## FIRST & CEDAR APARTMENTS

Studio apartments for currently homeless individuals

Early Design Guidance

April 8, 2008

**CREATE A TRANSPARENT CORNER AT THE ALLEY**

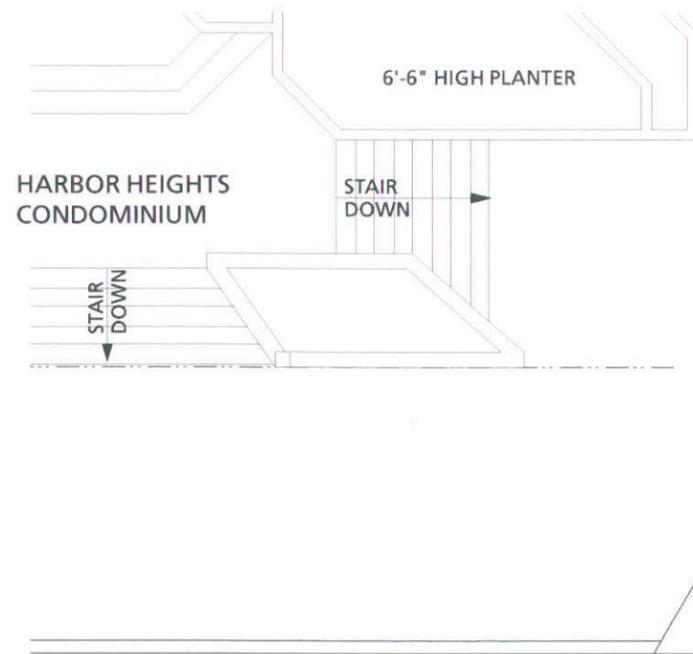
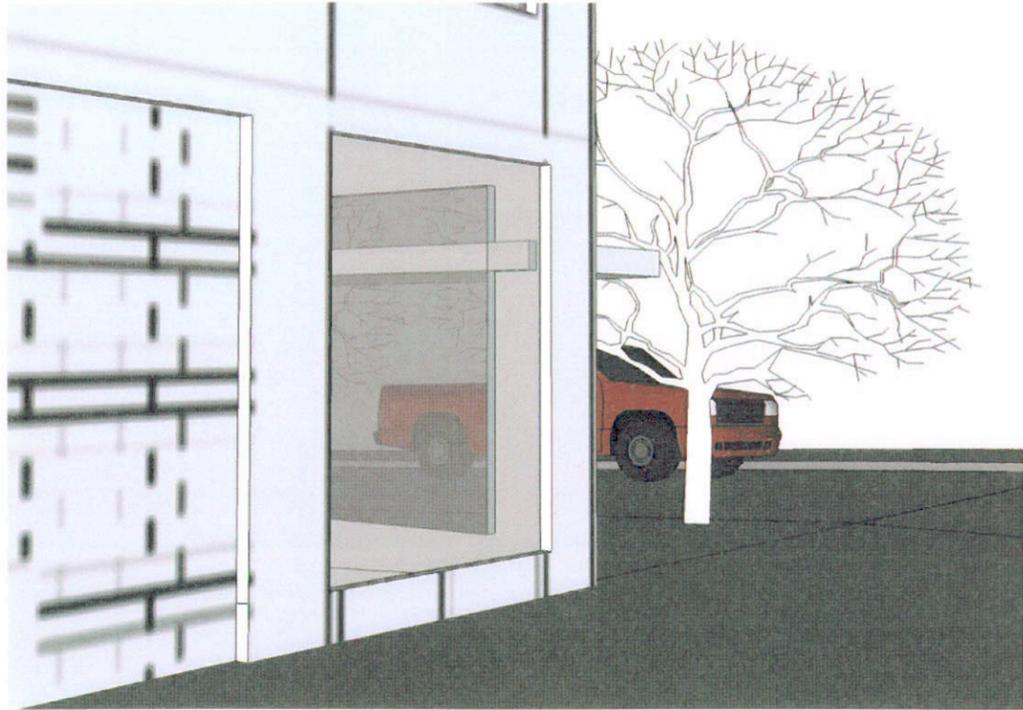
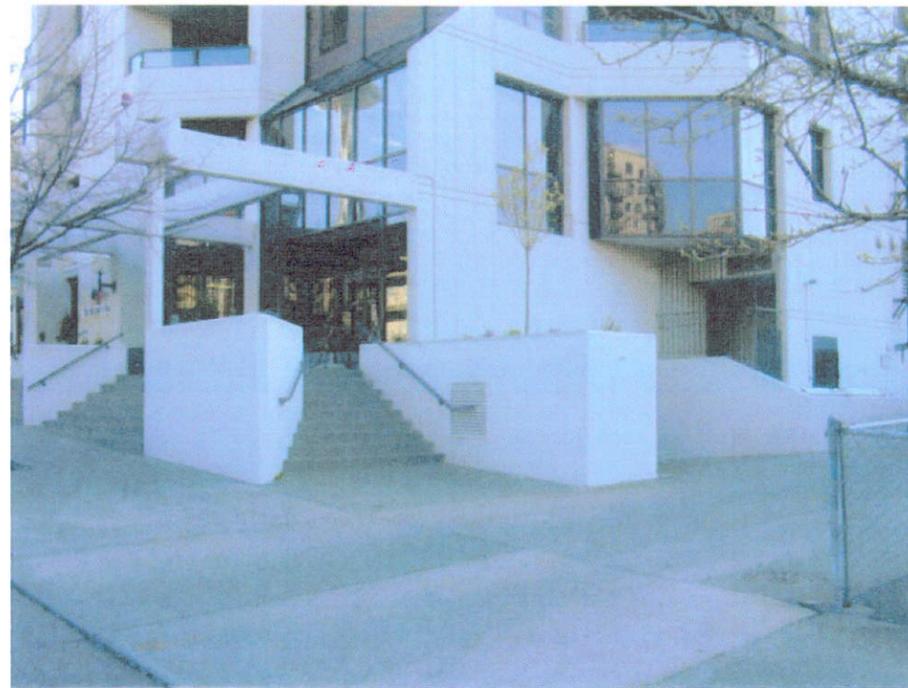
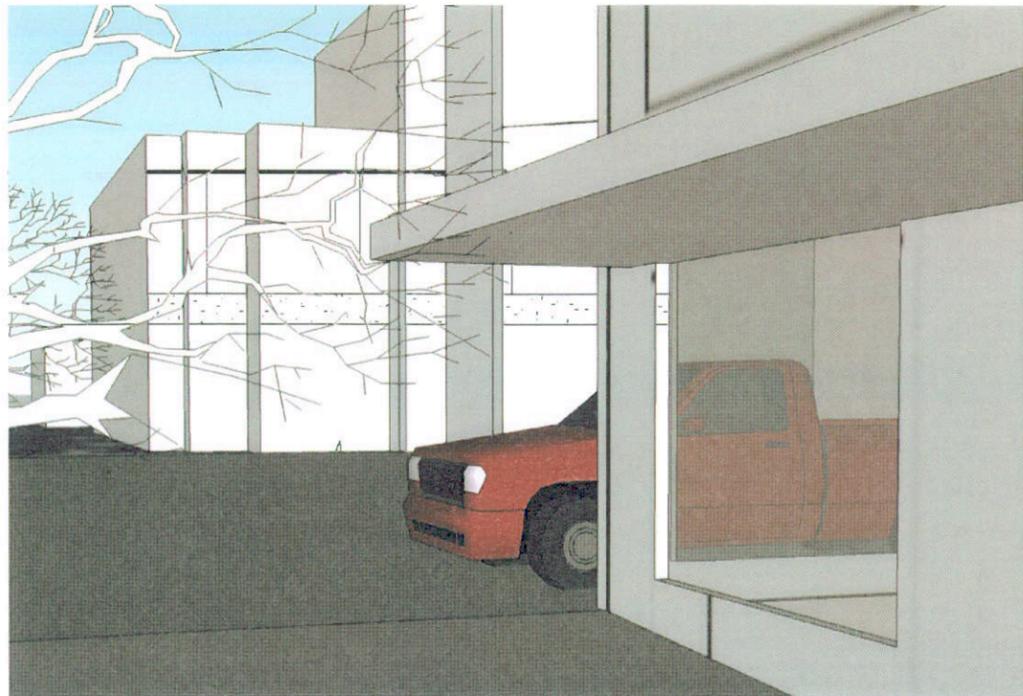
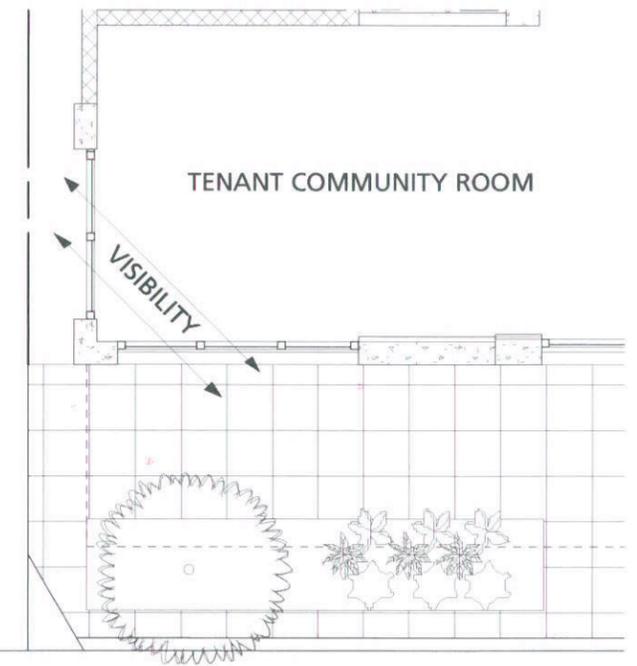
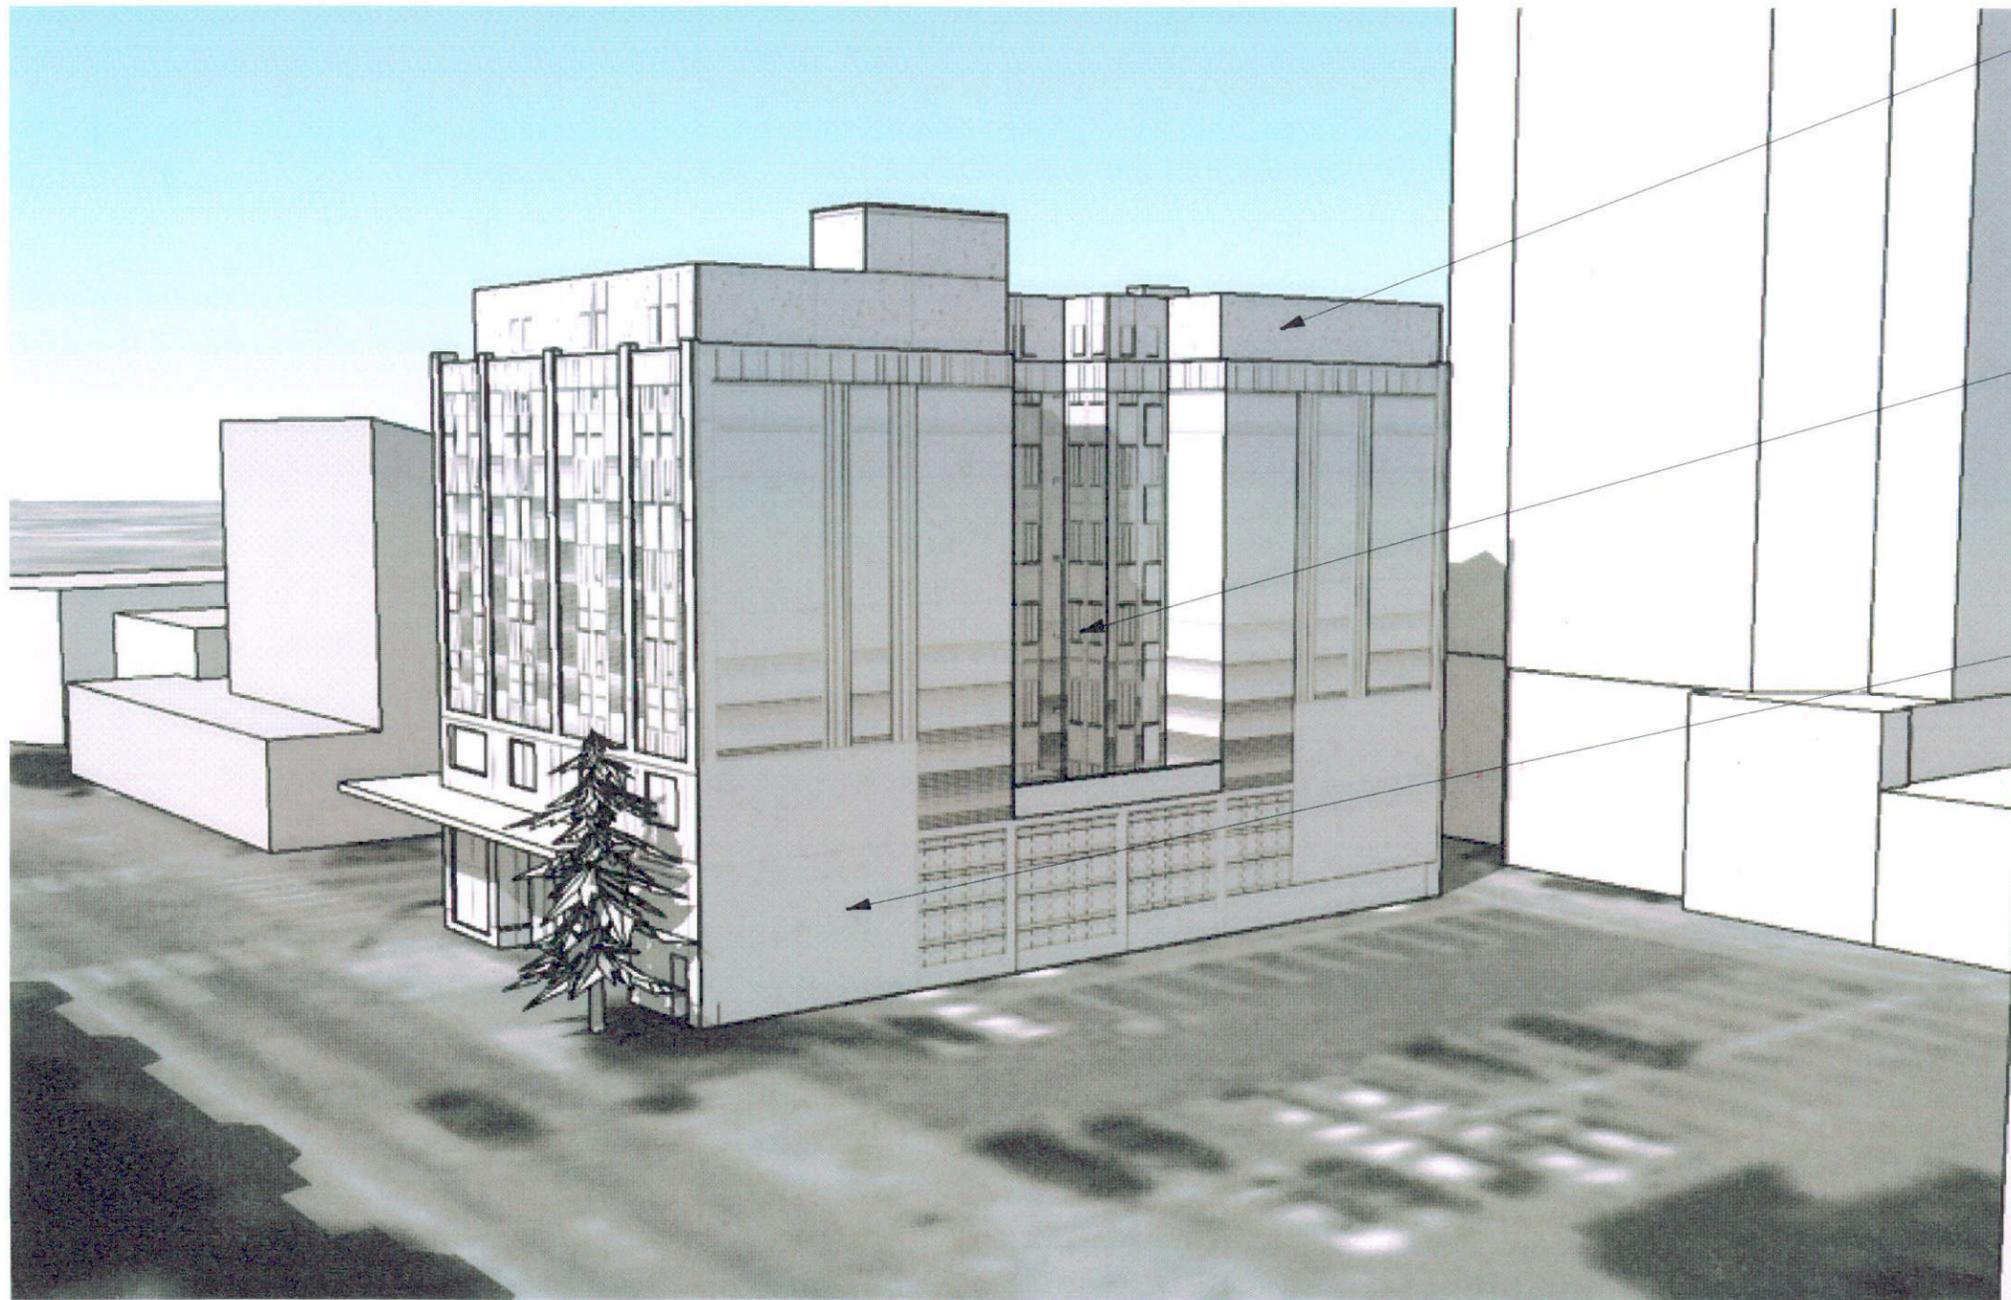
AT EDG 1, NEIGHBORS WERE CONCERNED WITH ALLEY VEHICULAR VISIBILITY. THE DRB WAS CONCERNED WITH THE BLANK FACADE PRESENTED AT THE ALLEY. WE UNDERTOOK AN ANALYSIS OF LOCAL CONDITIONS AND LEARNED THAT MOST BUILDINGS IN NORTH BELLTOWN ARE BUILT TO THE 2' DEDICATION LINE. MANY, (#4 + #5) HAVE BAYS ABOVE 26' THAT EXTEND TO THE PROPERTY LINE. WE (#12) HAVE CREATED A TRANSPARENT CORNER AT THE ALLEY. UNLIKE #2 + #11, WHICH ARE MESH, OUR CORNER IS STOREFRONT GLASS.

THIS PROJECT RESPONDS TO OUR IMMEDIATE NEIGHBOR ACROSS THE ALLEY, HARBOR HEIGHTS, AND TO ITS OWNERS' CONCERNS, IN SEVERAL WAYS. ON THE FIRST FLOOR, THE LARGE TENANT COMMON ROOM HAS BEEN SITED ON THE ALLEY, TO PROVIDE TRANSPARENCY AT THE ALLEY'S INTERSECTION WITH THE CEDAR STREET SIDEWALK AS WELL AS TO AVOID A BLANK FACADE AT THE ALLEY.

**DEVELOP A PLEASING SOUTH ELEVATION**

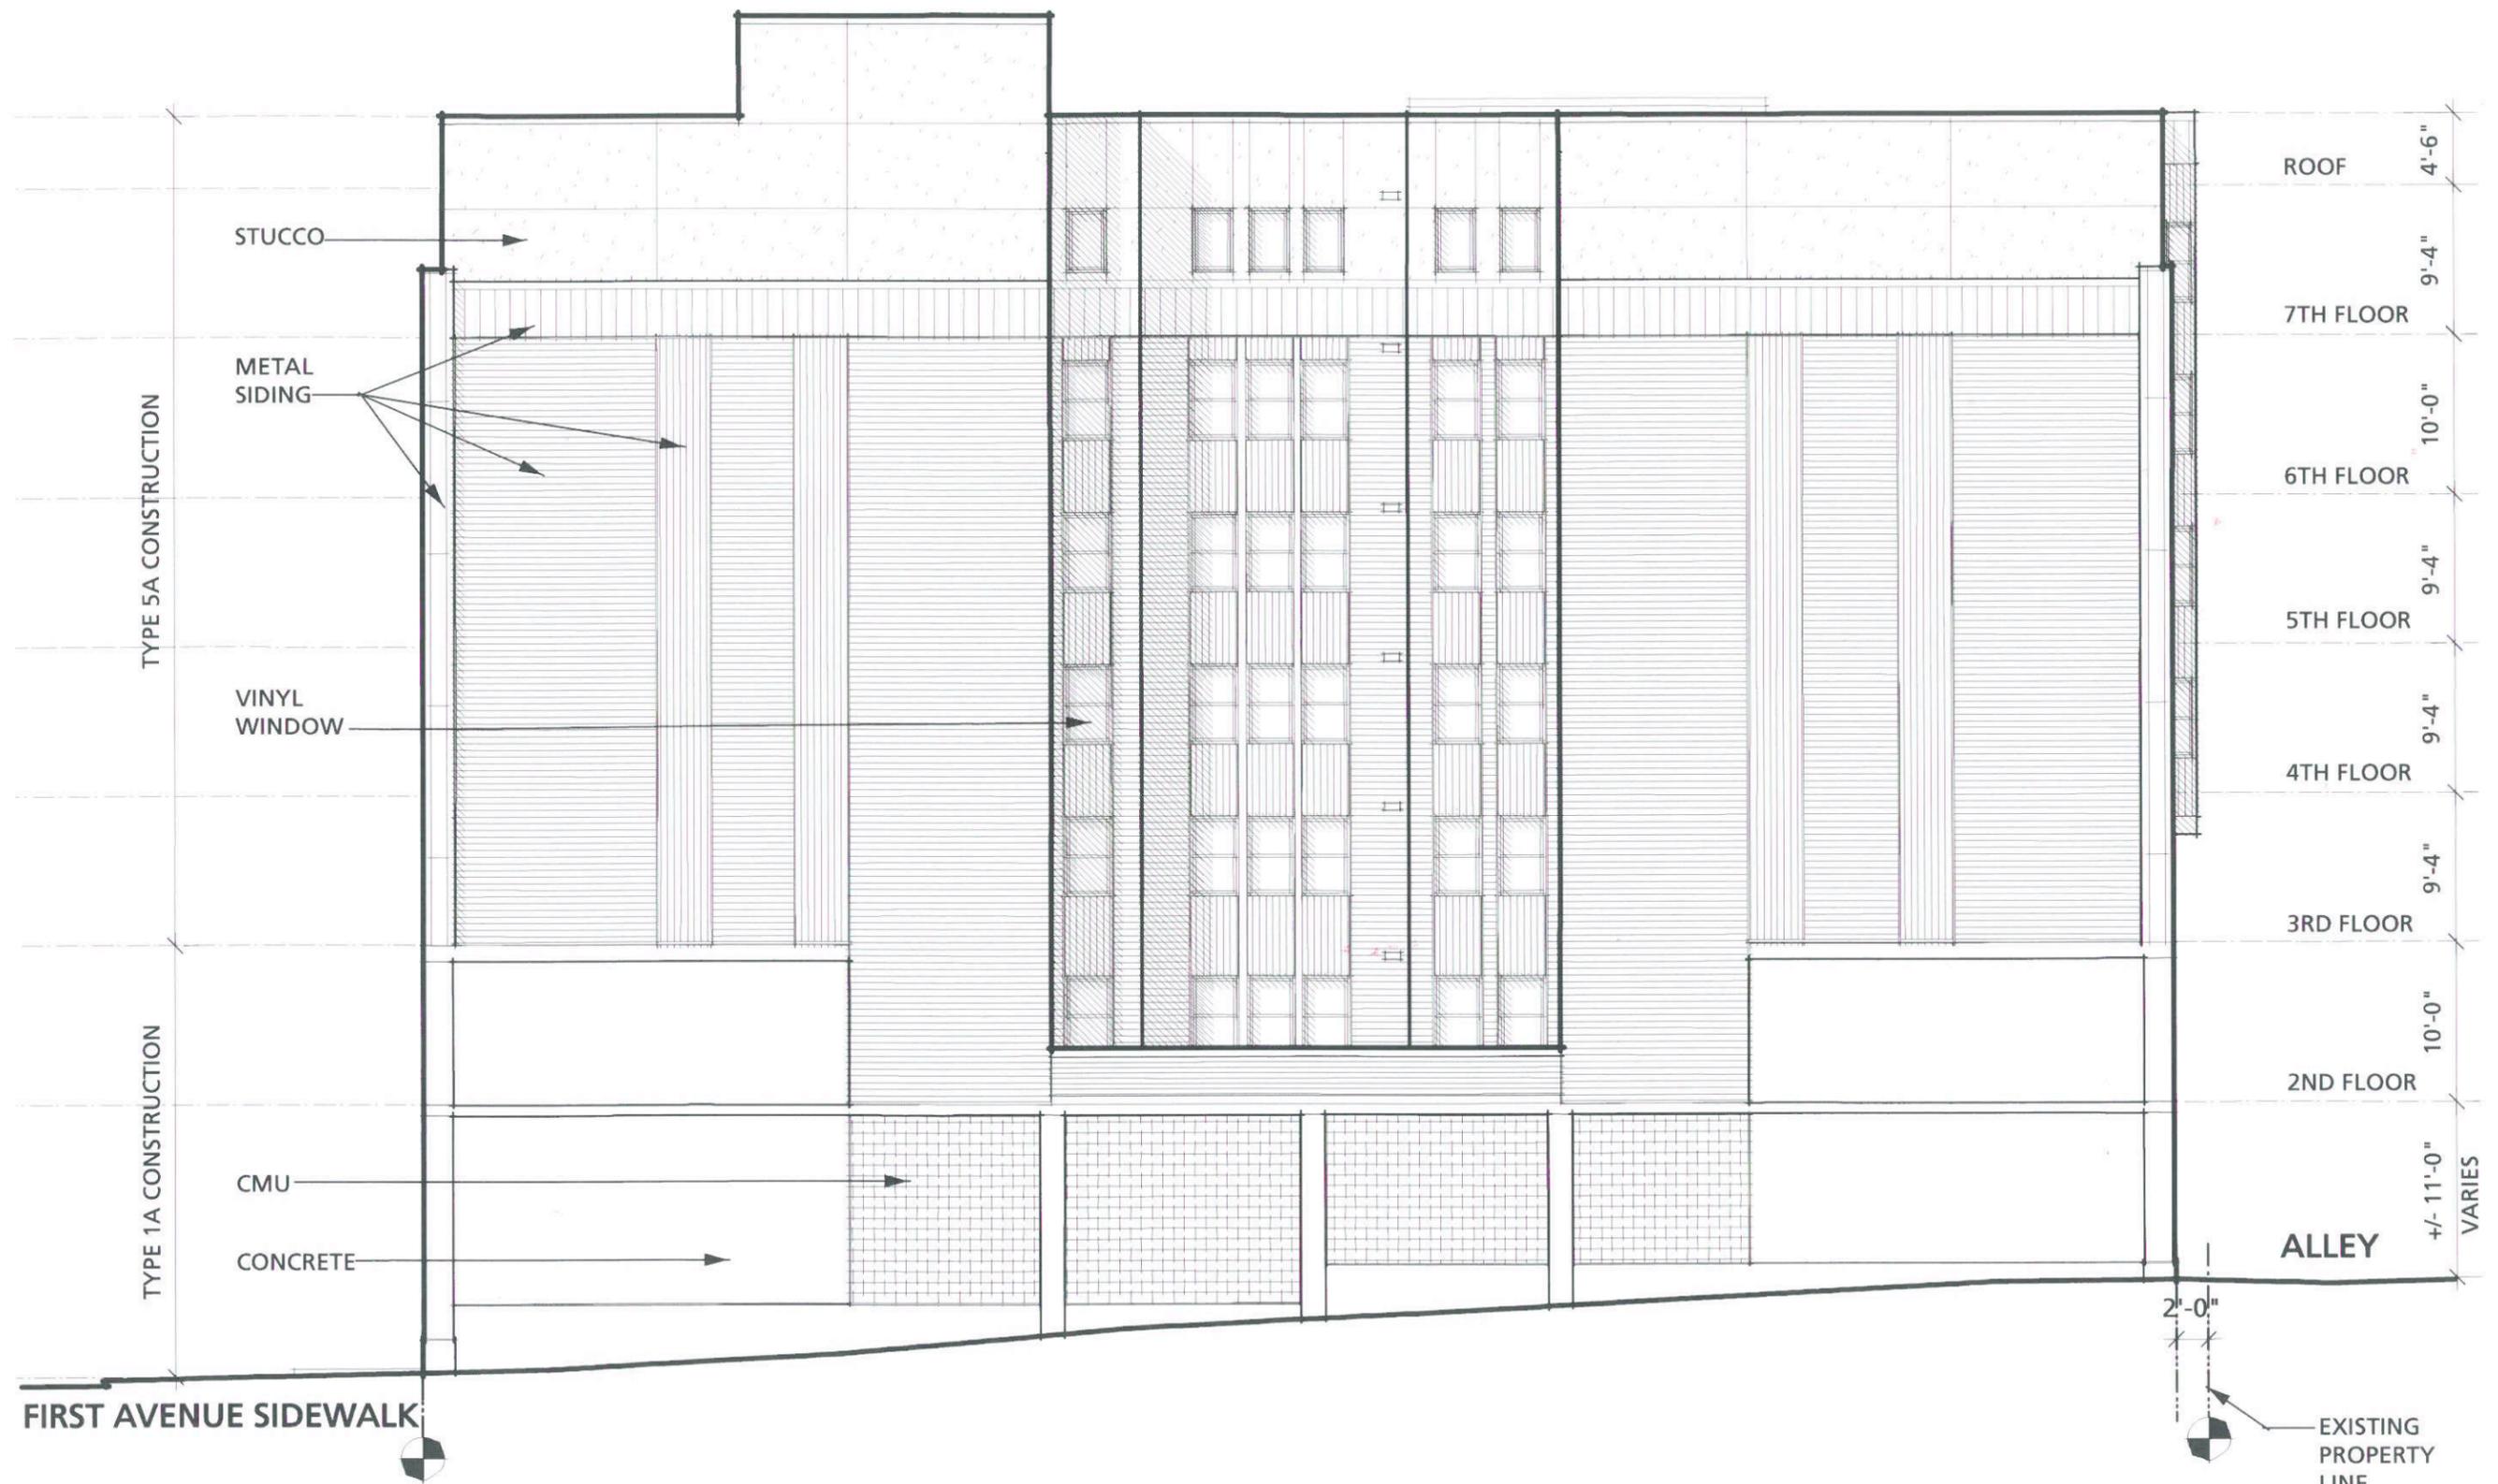
THE SURFACE PARKING LOT ABUTTING TO THE SOUTH IS NOT SLATED FOR DEVELOPMENT AT THIS TIME: THE OWNER WAS NOT INTERESTED IN SELLING THE LOT AT THE TIME OUR LOT WAS ON THE MARKET. WE HAVE DEVELOPED THE SOUTH ELEVATION OF THE PROJECT ASSUMING IT WILL BE VISIBLE FROM FIRST AVENUE FOR SOME TIME. THE MASSING IS BROKEN AT THE CENTER WITH A LIGHT COURT FOR 18 UNITS. WHILE FUTURE DEVELOPMENT PRECLUDES WINDOWS ON THE PROPERTY LINE, THE FACADE EMPLOYS MATERIALS CONSISTENT WITH THE REST OF THE BUILDING.

THE SAME MATERIAL CHANGE THAT DEFINES THE GREEN STREET SETBACK ON THE NORTH ELEVATION, DEFINES THE "TOP" OF THE BUILDING AT THIS SOUTH ELEVATION. ARCHITECTURAL METAL WRAPS AROUND THE CORNERS TO THE SOUTH ON FLOORS 2-6, THEN TRANSITIONS TO STUCCO FOR THE SEVENTH FLOOR.

THREE UNITS ON EACH RESIDENTIAL FLOOR LOOK ONTO THE LIGHT COURT. EACH UNIT HAS THREE WINDOWS, INSTEAD OF THE TYPICAL TWO IN ORDER TO MAXIMIZE LIGHT WHEN THE PARKING LOT OWNER DEVELOPS HIS SITE. THE COURT IS 19' DEEP AT ITS DEEPEST.

CAST-IN-PLACE CONCRETE ANCHORS THE FIRST TWO FLOORS AT THE ALLEY EDGE AND THE FIRST AVENUE EDGE. CMU PROVIDES INFILL DIRECTLY UNDER THE FLOOR OF THE LIGHT COURT AT THE SECOND LEVEL.
